11/14/97	Plan revised to indicate pedestrian and bicycle safe grate GDI's.
DATE	REVISION
STATE OF HAWAII DEPARTMENT OF TRANSPORTATION HIGHWAYS DIVISION	
DRAINAGE PLAN	
VOLCANO RD. DRAINAGE IMPROVEMENTS	
Vicinity of Keau Town	
F.A. Proj. No. STP-011-2(30)	
Scale: 1"=40'	Date: Oct 1997
SHEET No. <i>HI</i> OF 6 SHEETS

DRAINAGE DETAILS
VOLCANO RD. DRAINAGE IMPROVEMENTS
Vicinity of Keaau Town
F.A. Proj. No. STP-011-2(30)
Scale: 3/4" = 1'-0"
Date: Oct 1997

STATE OF HAWAII DEPARTMENT OF TRANSPORTATION HIGHWAYS DIVISION
DRAINAGE DETAILS
VOLCANO RD. DRAINAGE IMPROVEMENTS Vicinity of Keaau Town F.A. Proj. No. STP-011-2(30)
Scale: 3/4" = 1'-0" Date: Oct 1997
SHEET No. H4 OF 6 SHEETS

* Note: Pavement Restoration shall be incidental to the Drywell.

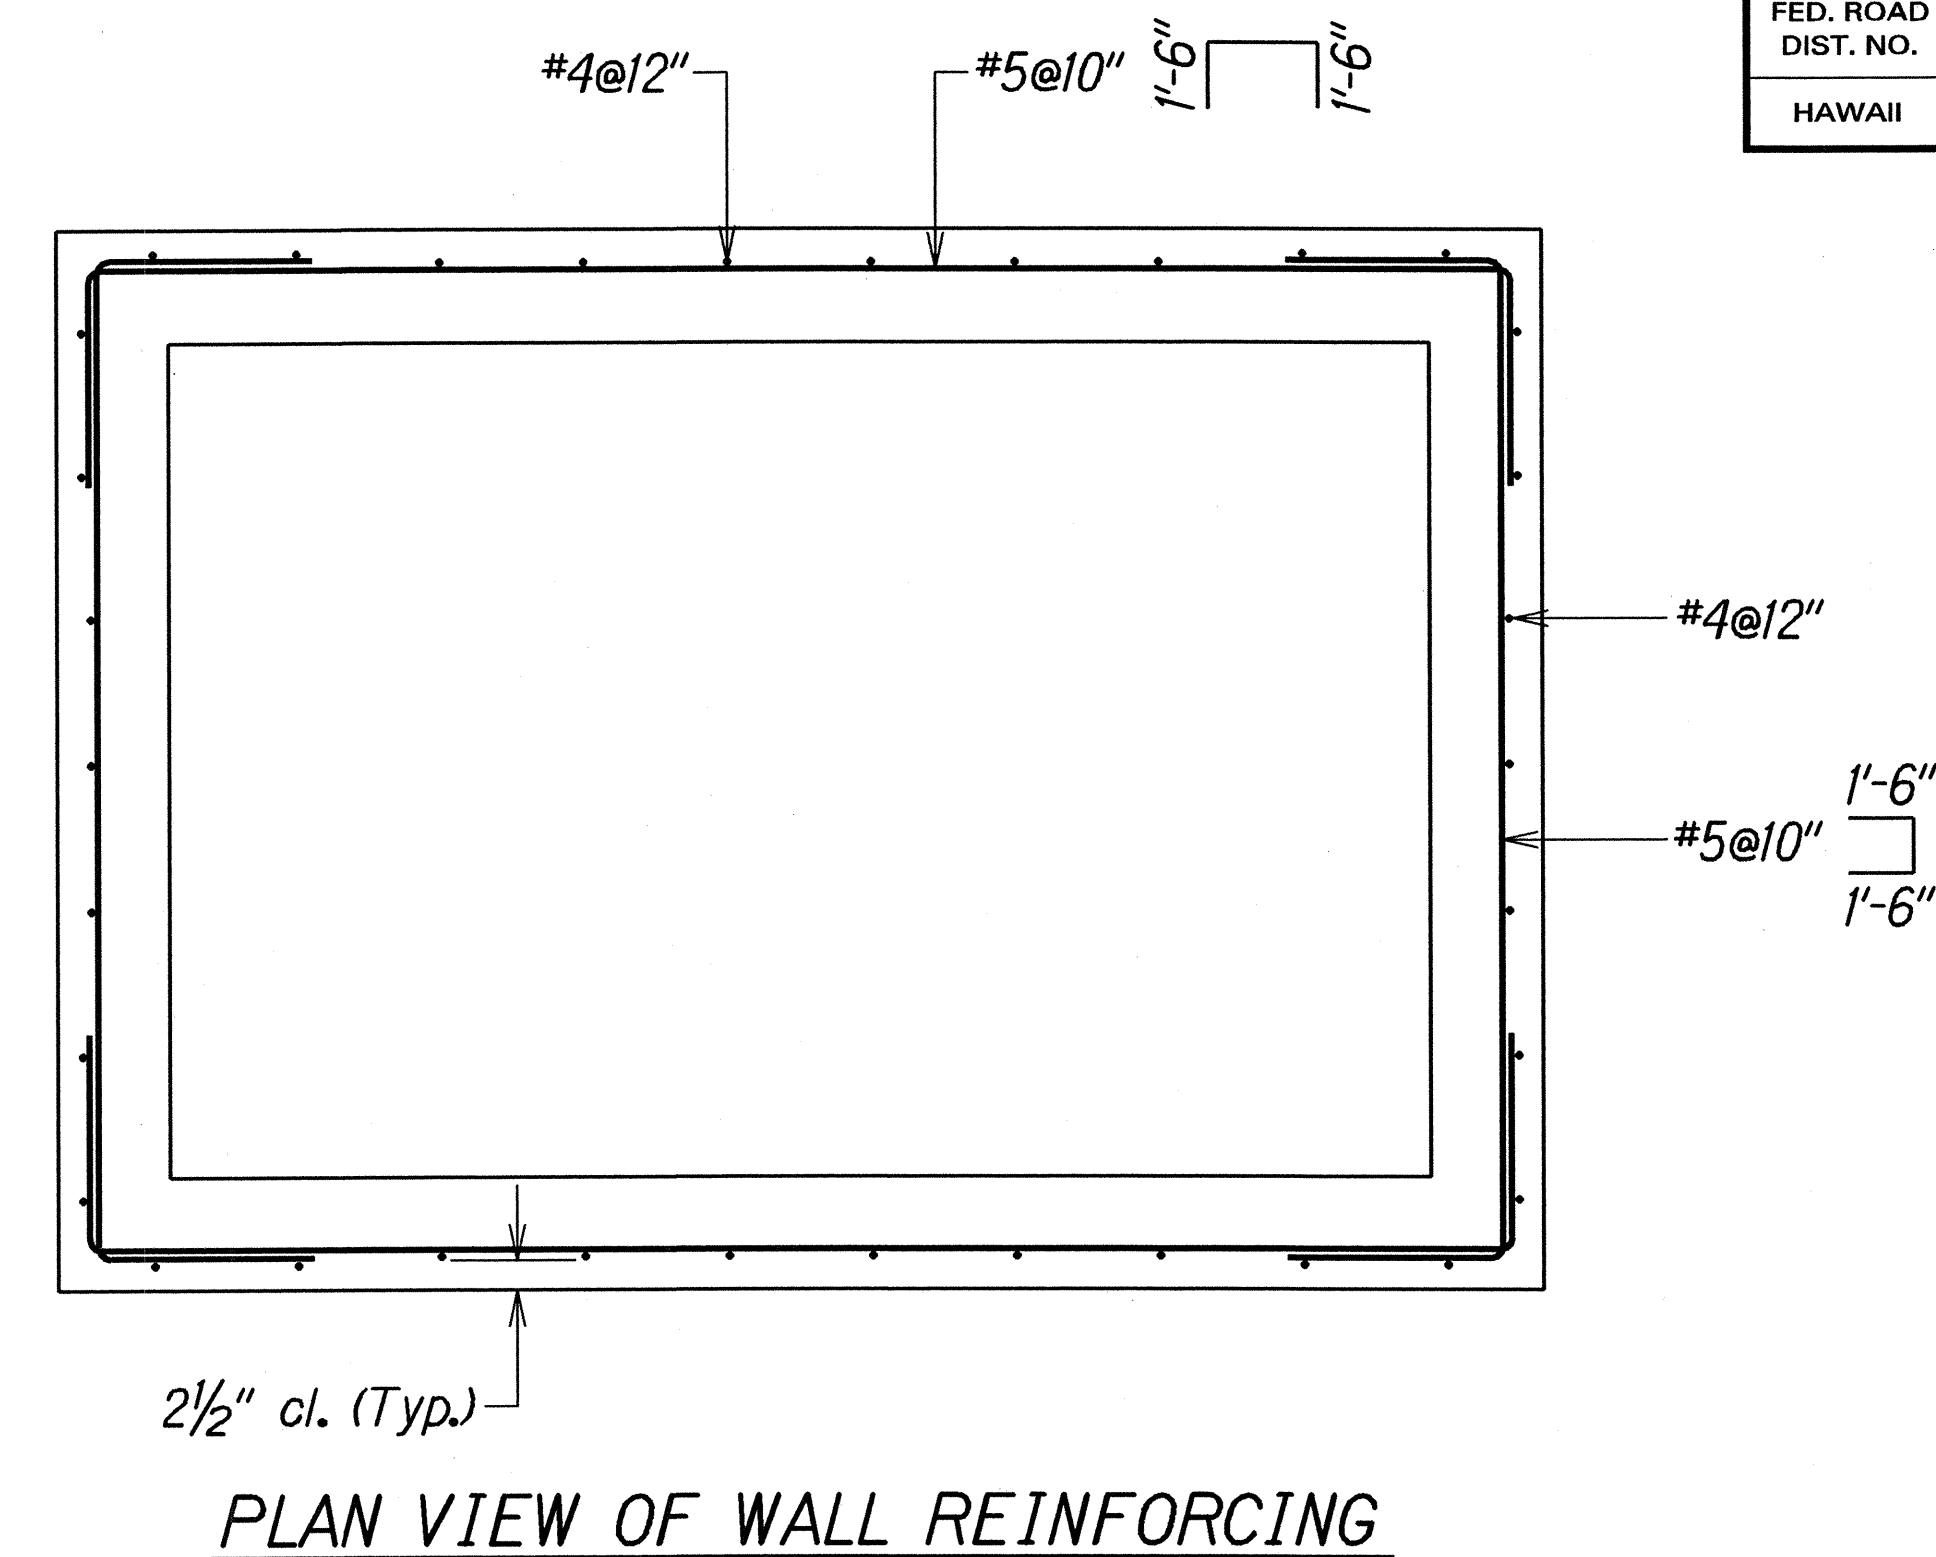
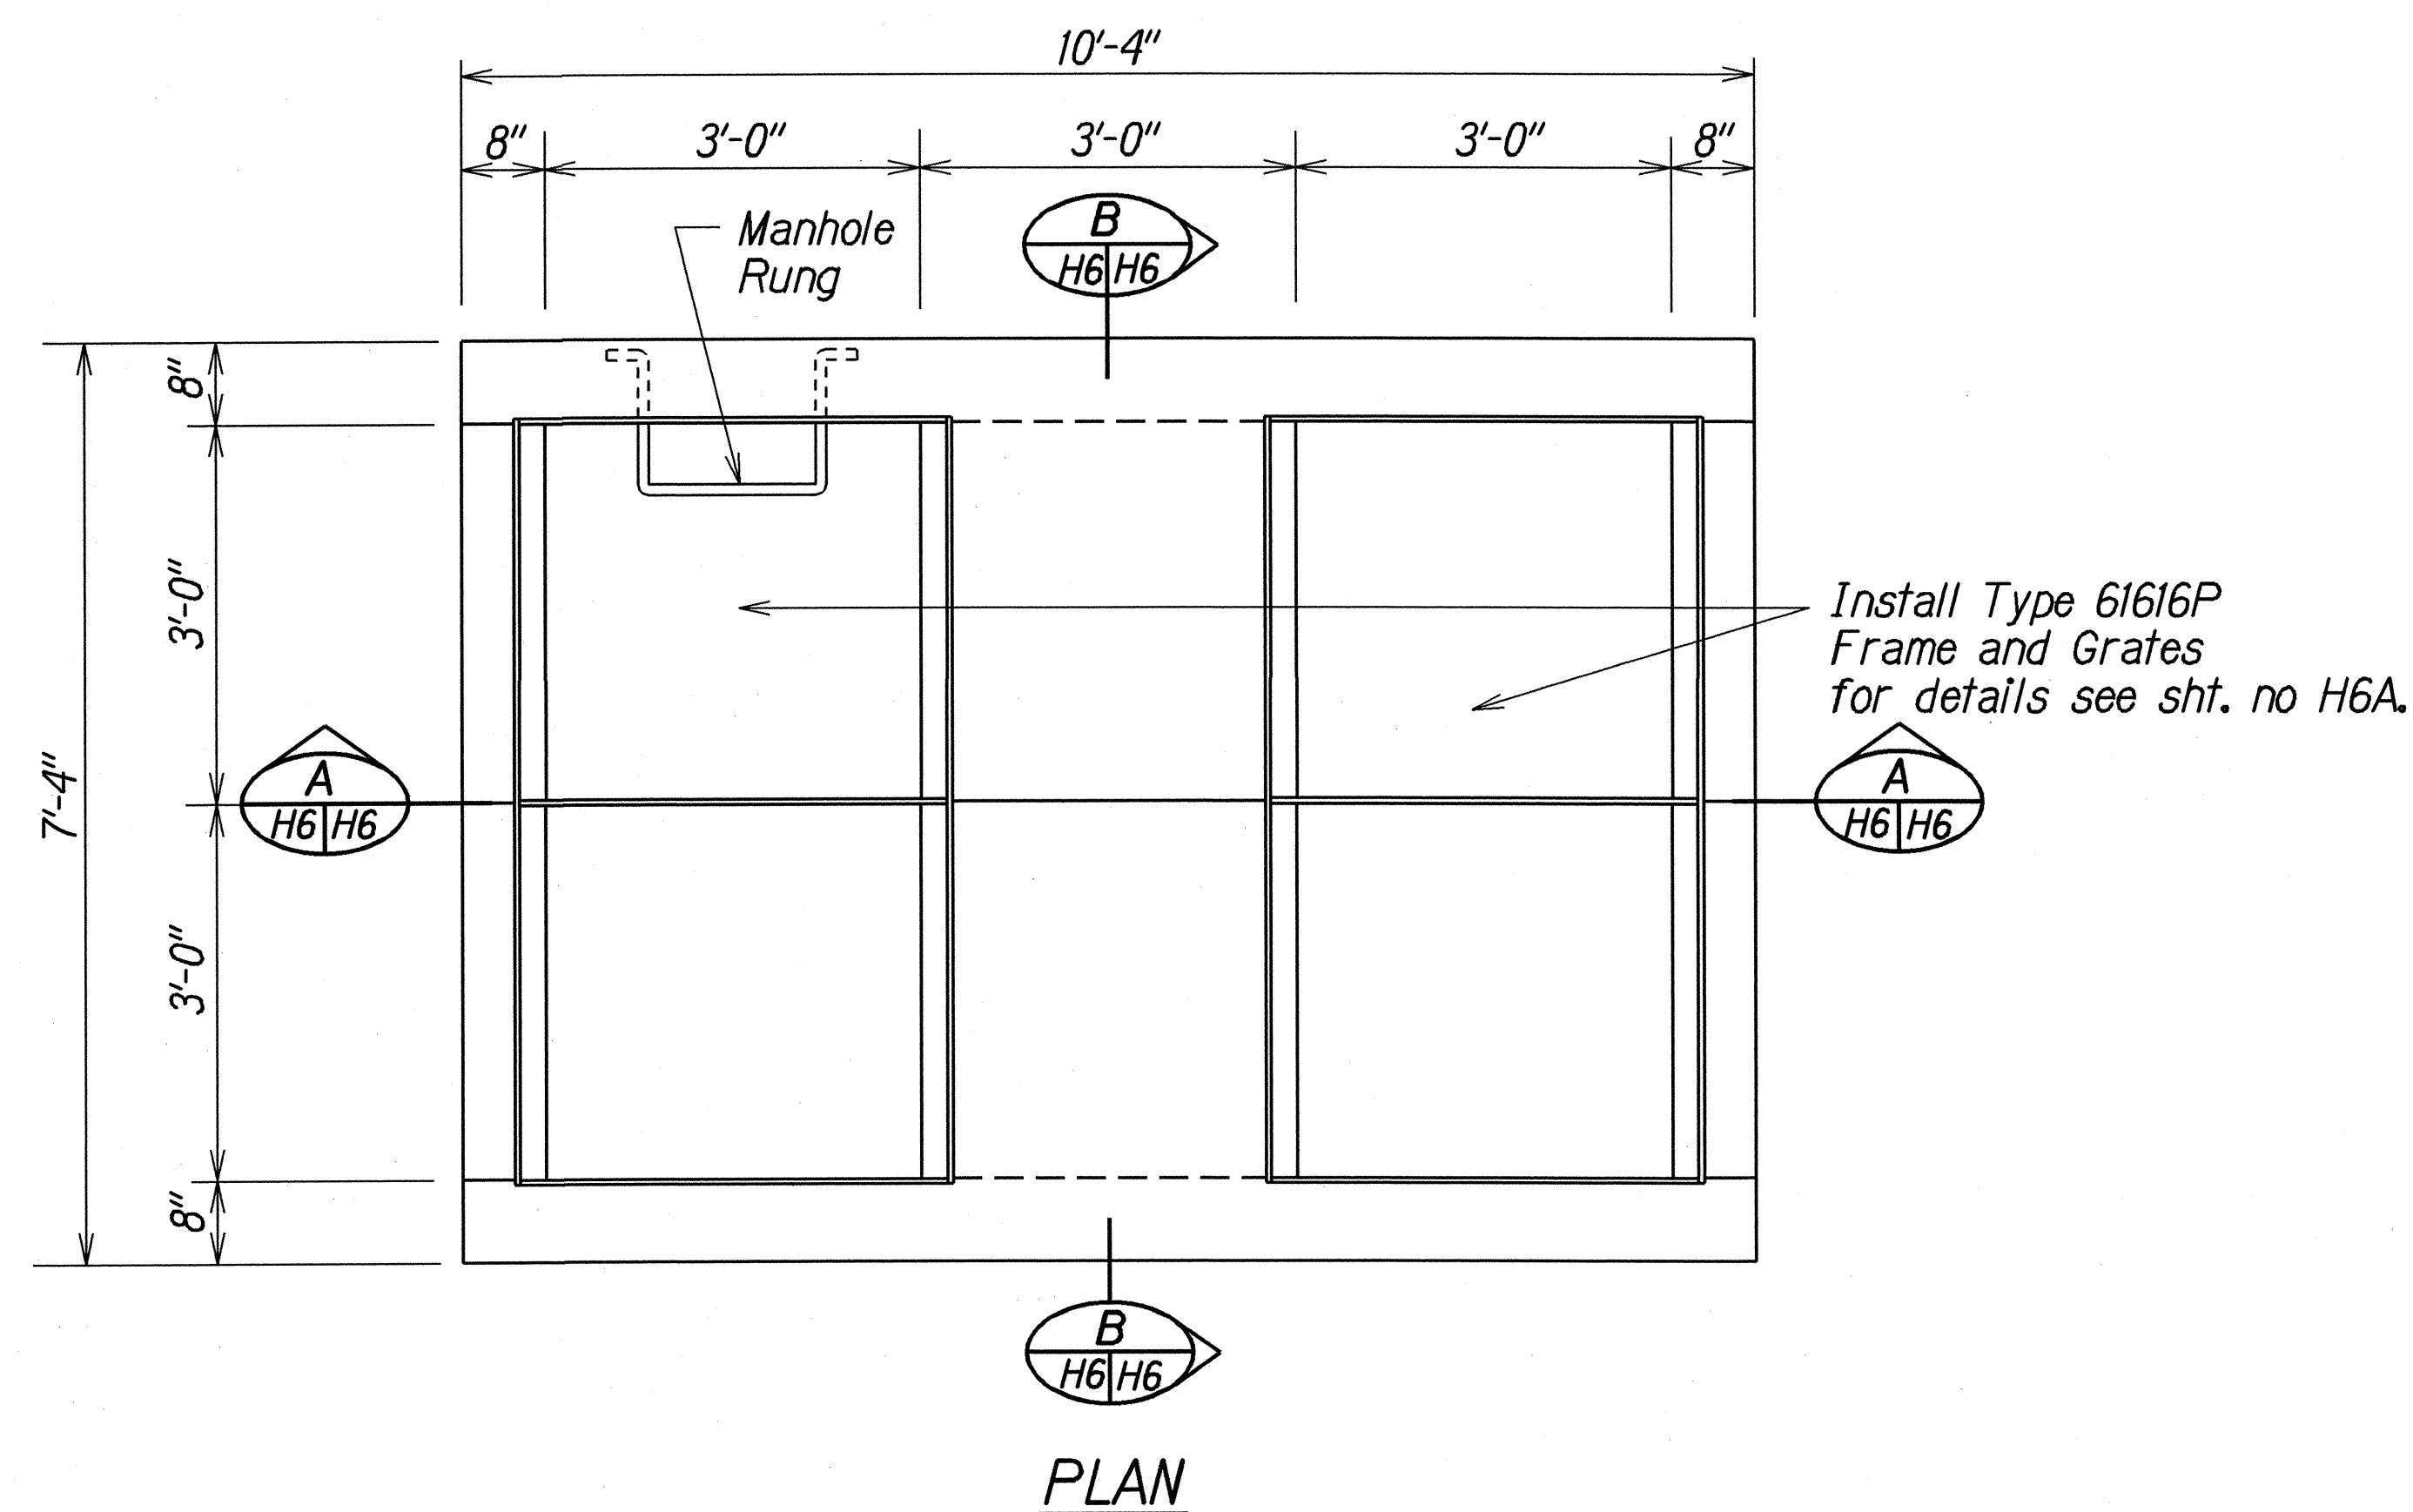
11/14/97	Revised to make grates pedestrian and bicycle safe.
DATE	REVISION
STATE OF HAWAII DEPARTMENT OF TRANSPORTATION HIGHWAYS DIVISION	
DRAINAGE DETAILS	
VOLCANO RD. DRAINAGE IMPROVEMENTS	
Vicinity of Keaau Town	
F.A. Proj. No. STP-011-2(30)	
Scale: 3/4"=1'-0"	Date: Oct 1997
SHEET No. H6 OF 6 SHEETS
